Site Address: 5427 BANDERAS WY SAC
Parcel No: 201-0380-053

Nature of Work: PATIO COVER

**CITY OF SACRAMENTO DEVELOPMENT SERVICES DIVISION
PLANNING AND ZONING INFORMATION REQUEST**

RE: ARCHITECTURAL REVIEW – LOT V4NBL53

Plot Plan

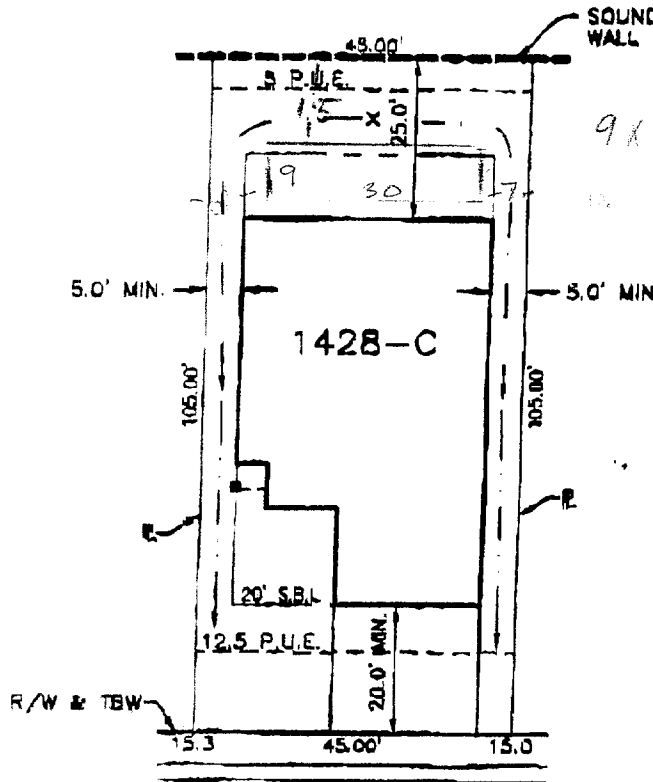
Comments: Revised patio cover - 9 x 30'
meets lot coverage max (45% allowed)
meets

Needs sign off by D.R. due to thru street
patio faces the back onto a street.

Comments: This would exceed maximum lot coverage - a variance would be required.

PLAN LAYOUT

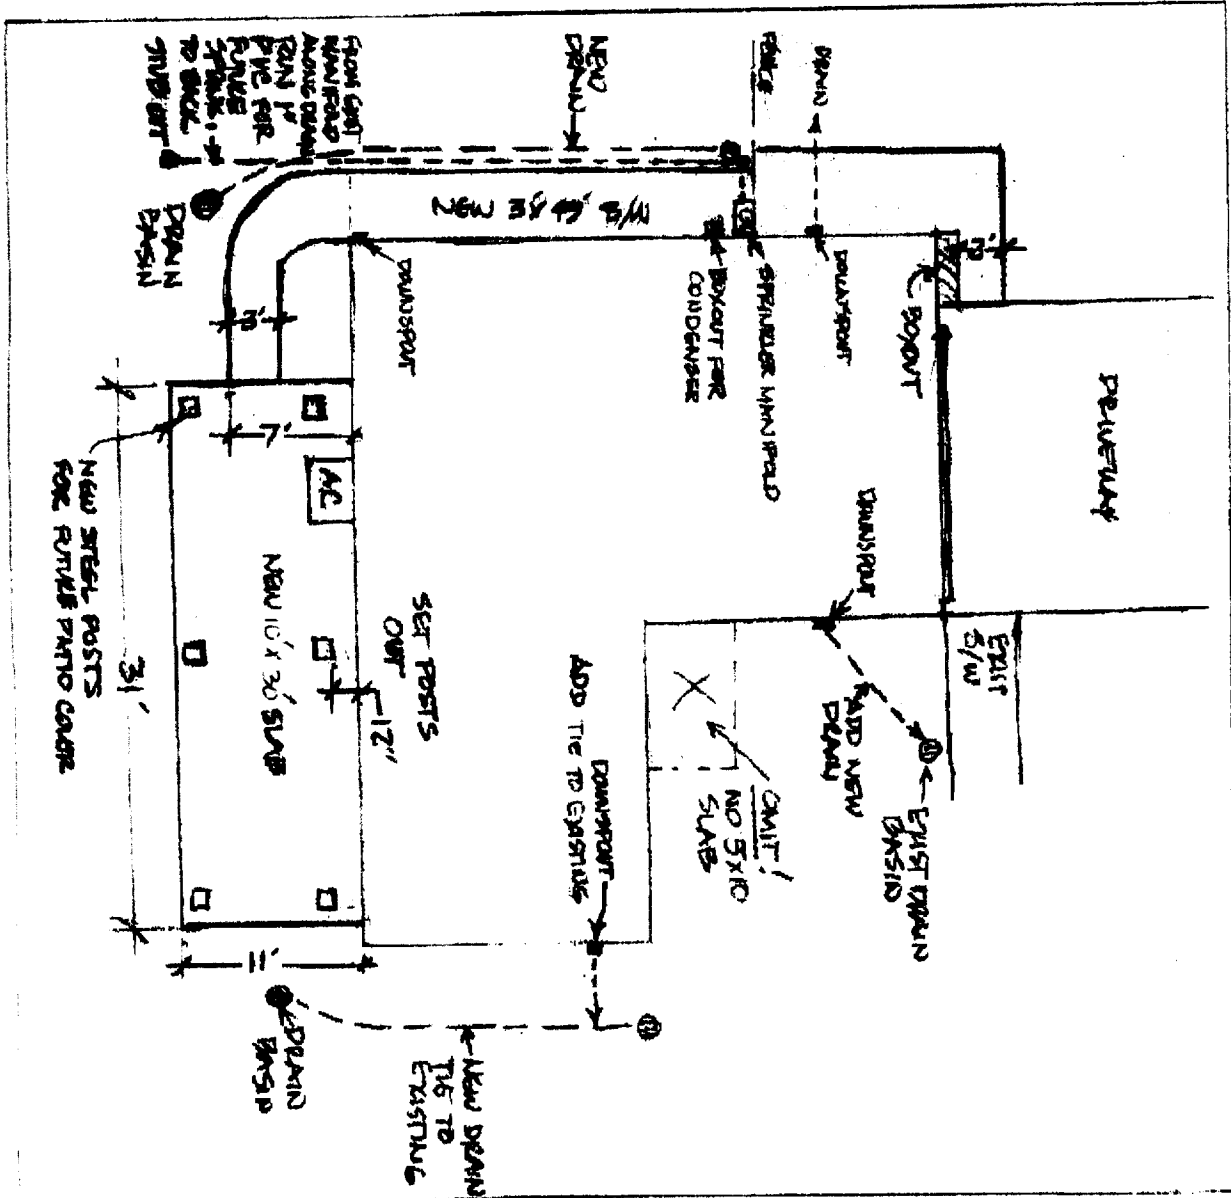
Need DR.

Revised
THE PLAN APPROVED: PLANNING DIVISION
